**Brookhaven National Laboratory**  
**Plant Engineering - E&CS Division**  
**Engineering Change Notice Form**

**PROJECT:** CCWF II

**ECN Title:** Exposed Duct Bank Bent Plate

**ECN No.** 22

ECN# 22	302D SECTION DETAIL
JOB: CENTRAL CHILLED WATER FACILITY PHASE II	
SCALE: 3/4"=1'-0"	
DATE: JANUARY 20, 2010	
DRAWN BY: BNK

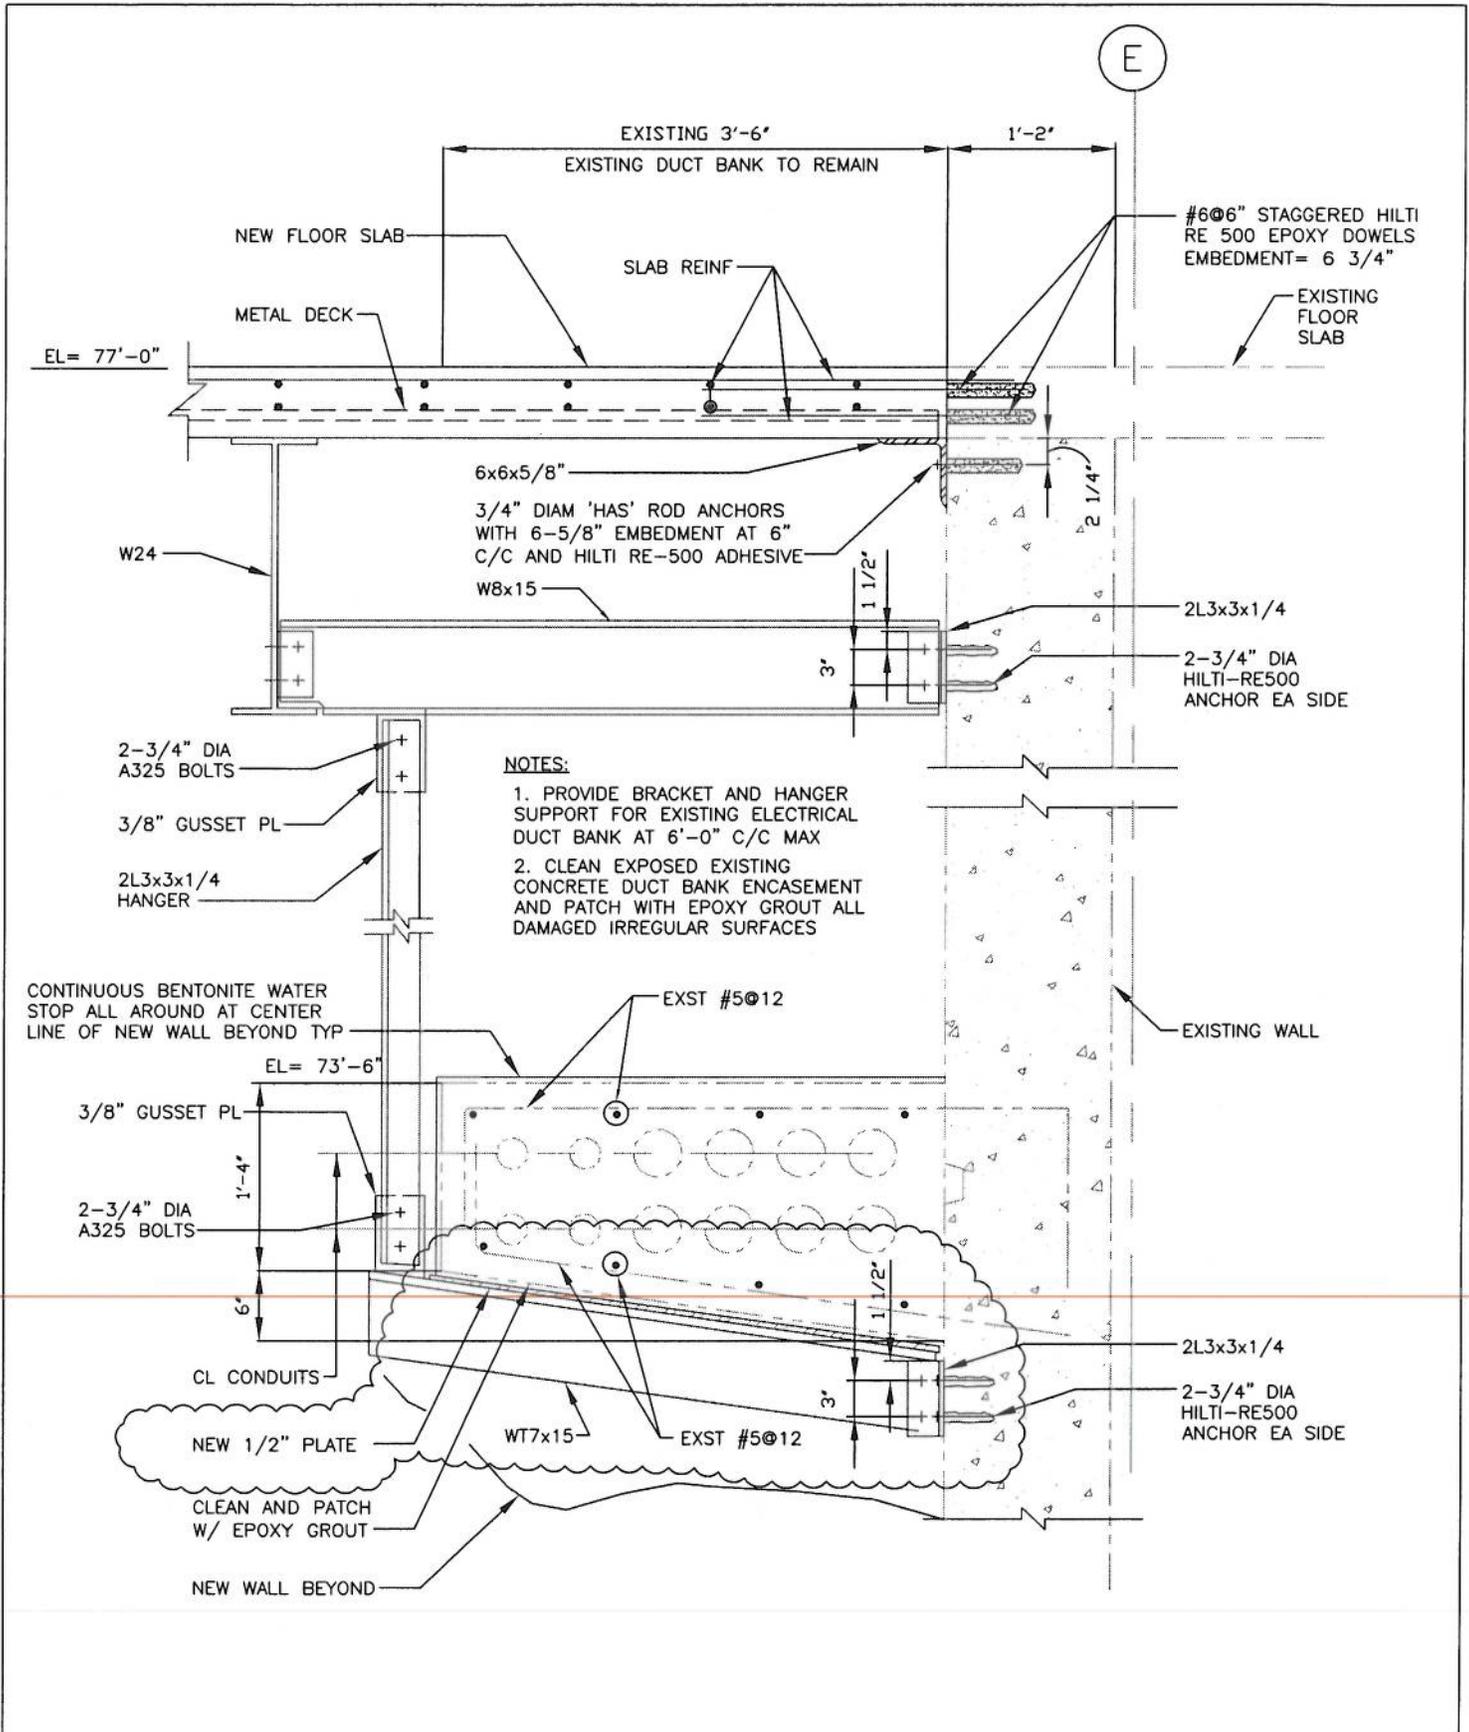
Requested Change (Attach sketch if applicable): Propose continuous 1/2" steel plate support for duct bank at each WT7x15 in lieu of bent plate on corner.

Resolution: See the attached sketch.

- NOTES:**
1. PROVIDE BRACKET AND HANGER SUPPORT FOR EXISTING ELECTRICAL DUCT BANK AT 6'-0" C/C MAX
  2. CLEAN EXPOSED EXISTING CONCRETE DUCT BANK ENCASEMENT AND PATCH WITH EPOXY GROUT ALL DAMAGED IRREGULAR SURFACES
